TE Connectivity

Product Change Notification: PCN-23-170310

Updated the product with UK CA certification and adding the same on the relay in the label

Before Image 	After Image

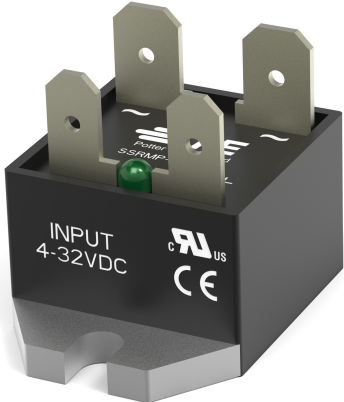
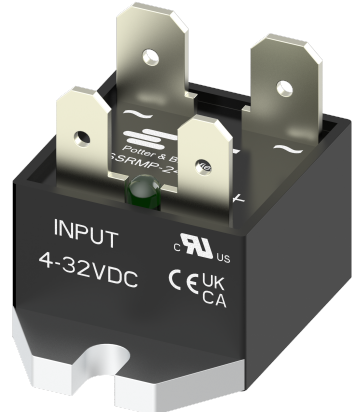
Please be aware of an upcoming specification change to the listed part numbers. Before: No UK CA marking After: Added UK CA marking Reference performance test data:
